**39 Oak Avenue
Ickenham
UB10 8LR**

PLANNING STATEMENT

Erection of a replacement dwellinghouse

Fig.1 – Comparison images showing the reduction in the crown roof profile

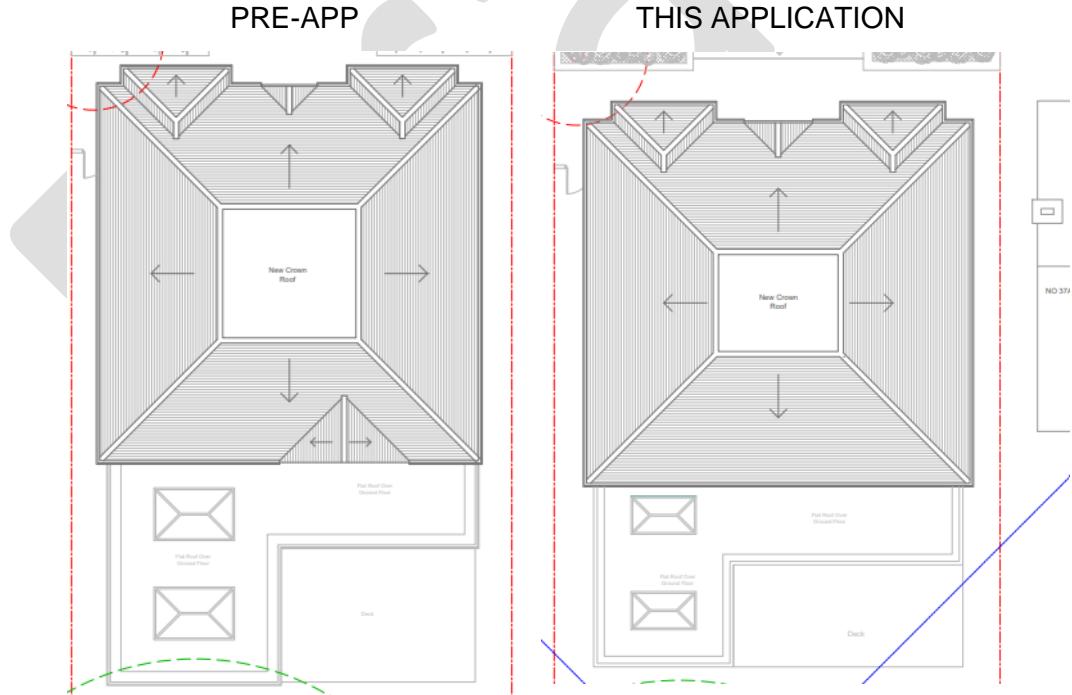
- 2.1 This council's pre-application response was supportive of the design concept of the replacement dwelling but requested that amendments be made to the crown roof profile in that '*the central flat roof element is reduced to resemble the appearance of the crown roof profile at no.38 Oak Avenue.*'
- 2.2 The crown roof profile has been amended in accordance with the council's request and this is demonstrated in Fig.1 below.

Fig.4 – Excerpt of proposed first floor plan showing the rear dormer window at no.41 in relation to the proposed first floor building line.

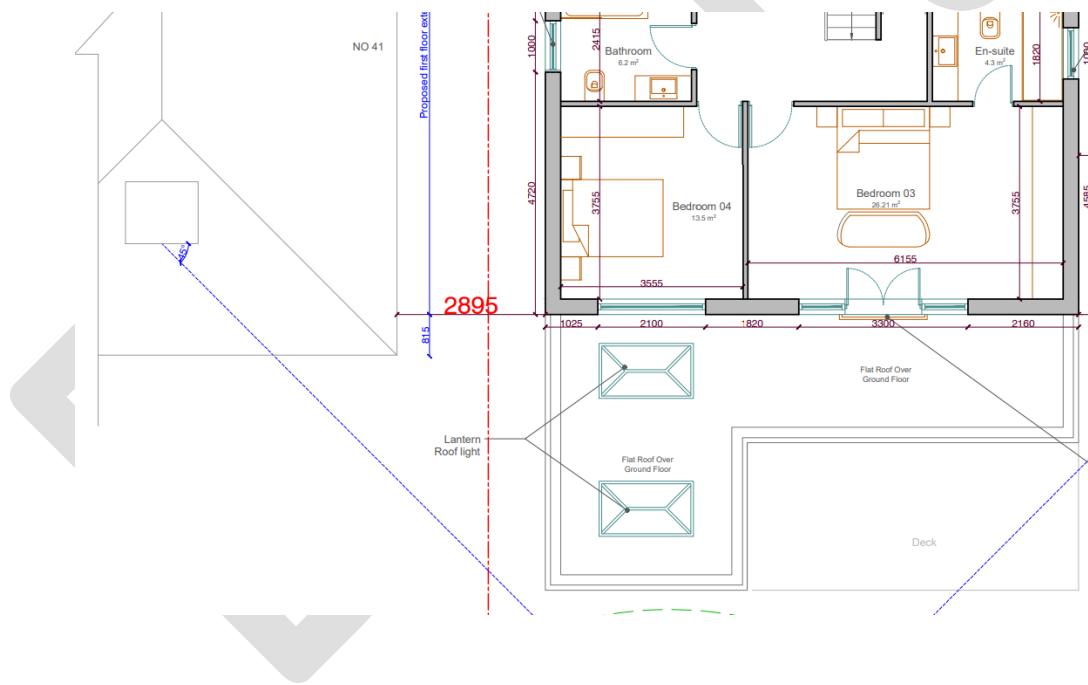
- 3.3 The council's pre-application comments were also concerned with the rear building line and how this would impact on the upper floor windows of the neighbouring properties on either side. The pre-application letter stated that:
'the rear building line would need to be reduced to overcome the harm caused to the living conditions of the occupiers of Nos. 37a and 41 Oak Avenue.' 45-degree test only relates to daylight and given position of dormers at 37a and 41, there will be unacceptable impression of enclosure which would be overbearing for these neighbouring occupiers. Also the outlook from these dormers would be severely undermined. Instead, it is strongly recommended that the depth of the proposed dwelling is reduced so that its

two-storey rear building line does not project beyond the rear dormer at no.37a (this would require a 1.6 metre depth reduction.'

3.6 The blue lines in Fig.3 above indicate the reasonable line of vision from this dormer window; as the proposed first floor of the replacement dwelling does not even project beyond the rear wall of no.41 (see Fig.4 below) it is simply impossible for no.41's rear dormer to be affected by the proposed development in terms of outlook or sense of enclosure. This dormer occupies a position very high up in the rear roof slope of no.41 and will be unaffected by the proposed development.

Fig.6 – Images showing views of the existing ground floor rear extension.

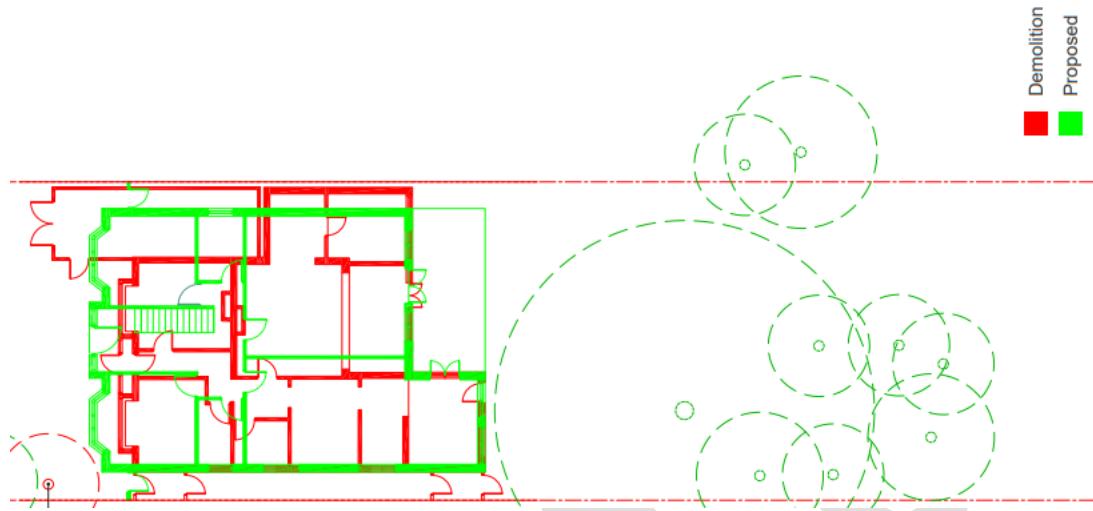
3.10 The pre-application advice also commented that the proposed ground floor depth (which proposed an additional 1-metre depth beyond the existing ground floor flat roof extension) was unacceptable, stating that: '*the depth of the ground floor rear element would be unacceptably overbearing for the occupiers at Nos. 37a and 41 Oak Avenue, given the position of these neighbours' ground floor windows. Officers would recommend that the proposed single storey rear element is reduced to coincide with the reduction at first floor level.*'

3.11 The proposed ground floor rear element has been amended so that it does not protrude beyond what is currently on site.

3.12 The images in Fig.6 below show the extent of the existing flat roof ground floor rear extension at the application site. As this extension is in-situ, it is entirely reasonable to re-build this built form. The proposed development simply replicates an existing and long-established situation. Fig.7 below shows the outline of the existing and proposed footprint.

Fig.11 – Excerpt of proposed forecourt plan

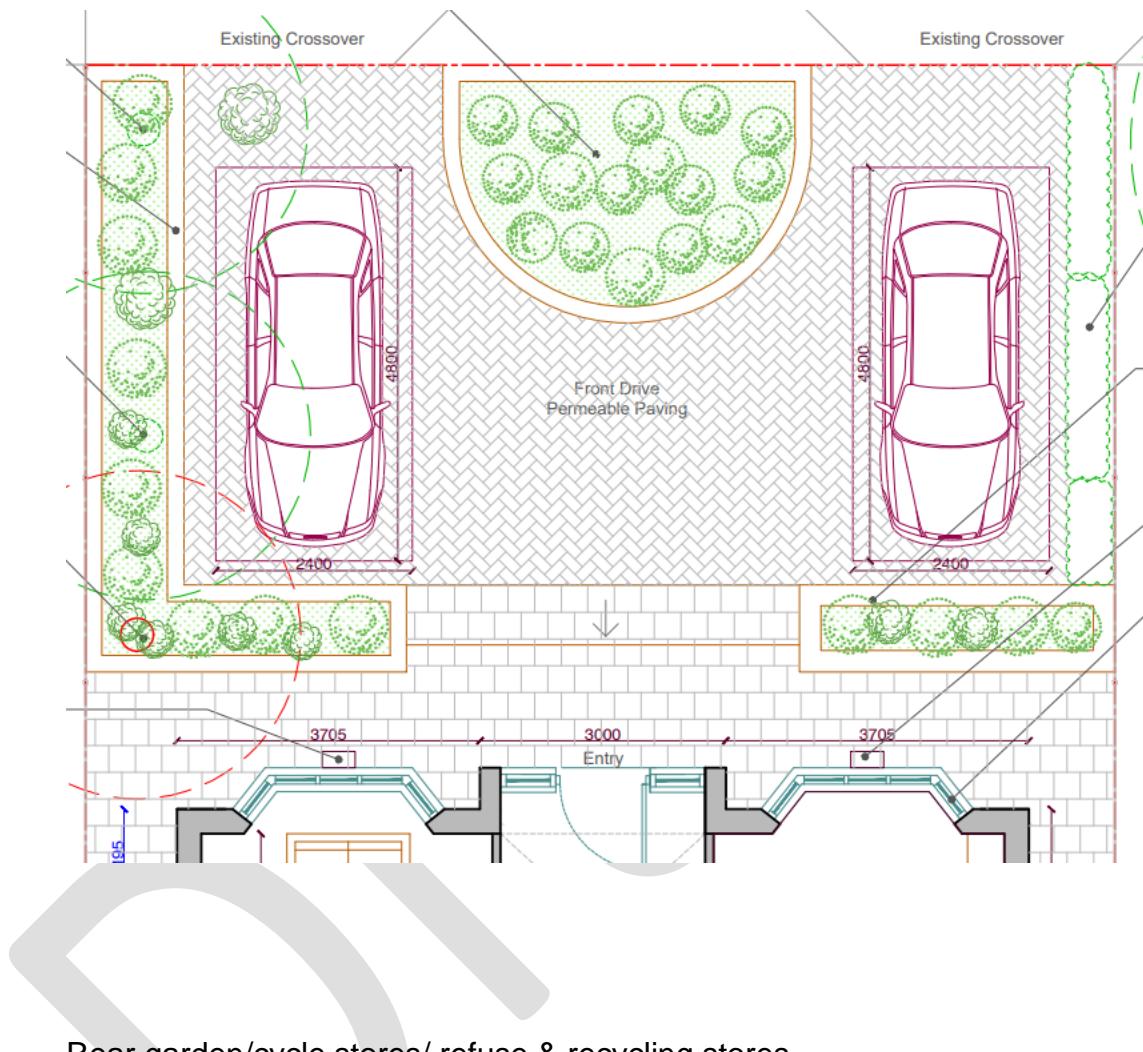
'Front garden is indicated as predominantly paved area, with space for four or five cars and minimal soft/living landscape. This arrangement would be detrimental to the character and appearance of the area. It is environmentally unsound with regard to air quality carbon capture and Sustainable Urban Drainage System (SuDs). A greater area of soft landscaping should be retained / reinstated as part of the layout. Also, the reduced area of hardstanding would need to be covered in permeable paving.'

4.2 The forecourt plan has been amended in line with the council's stipulations and parking is reduced to 2 off-street parking spaces and large areas of landscaping have been introduced as well as demonstrating that the paving will be permeable (see Fig.11 below).

4.3 In addition, the presence of the 2 existing crossovers is noted on the updated forecourt plan as well as position of wall-mounted EV charging points (on the main house) to comply with Policy T6 (T6.1) of the London Plan (2021).
